A29 REALIGNMENT (PHASE 1)

Stage 1 Road Safety Audit

OUR REF. NO. 70060779-RSA1-002

Road Safety Audit Stage 1
Designer's Response
July 2020

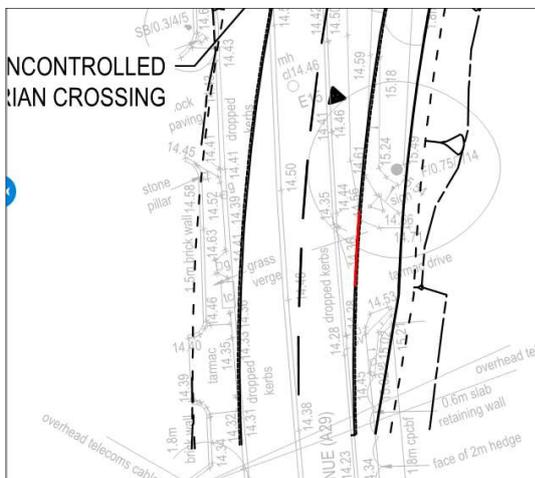
It is not clear how cyclists can join or leave the shared route on both of the existing A29 arms at the proposed A29 / Fontwell Avenue roundabout.

It is recommended that dropped kerbs and suitable markings are provided to allow cyclists to join and leave the proposed shared scheme on all approaches to the proposed roundabout.

The eastern footway on Fontwell Avenue will be widened for the length of the southern arm, a dropped kerb will be added during the detailed design:

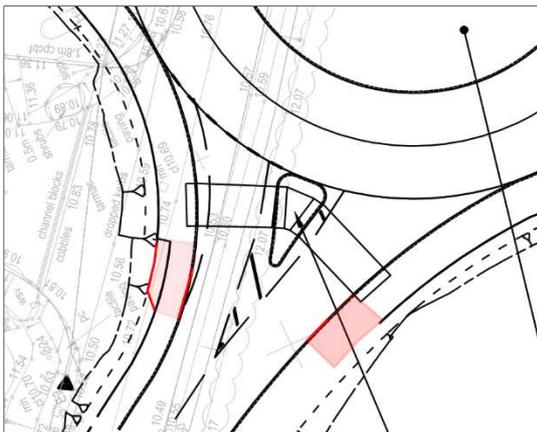
Following the January 2018 Stage 1 RSA, a shared use crossing is proposed across Barnham Road to the west of the proposed roundabout.

The existing footway on the northern side of Barnham Road is not currently designated as for shared use. It is recommended that the northern footway is widened to provide a shared use footway or that dropped kerbs, signs and markings are provided to enable cyclists to join/leave the shared footway.

It is also recommended that transition points for cyclists are provided on the western side of the proposed A29 / Barnham Road roundabout.

Agreed, the northern footway widening and southern footway will be extended westwards and dropped kerbs will be added during the detailed design. The transition length for the northern footway will be reviewed at detail design:

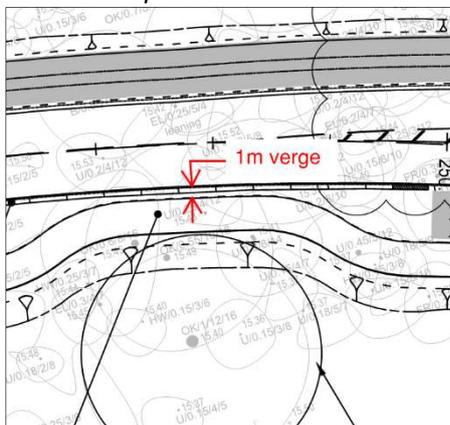
Summary: Quick alignment change on the footway/cycleway may result in pedestrian/cycle conflict, or cyclists being hit by passing large vehicles.

There is a tree with a protected 'no construction' area to the east of the Fontwell Avenue roundabout. The proposed footway/cycleway moves sharply around the tree protection area. Pedestrians will take the direct route along the path, which makes it likely that they will move laterally across the path. Cyclists wishing to overtake will be happier to follow the new alignment. This may result in collisions between pedestrians and cyclists at this point.

During the site visit, traffic flows on the existing A29 route were steady, including a relatively high number of HGVs and large farm vehicles. The changed alignment moves the footway/cycleway to approximately 1m from the live carriageway. The wing mirrors of large vehicles may overhang into this area, while cyclists may travel along the track, but have their handlebars closer. This may result in cyclists being hit by passing vehicles.

It is recommended that the footway/cycleway alignment is extended both upstream and downstream of the tree.

It is also recommended that the carriageway is moved north to provide a larger buffer zone between the live carriageway and the footway/ cycleway.
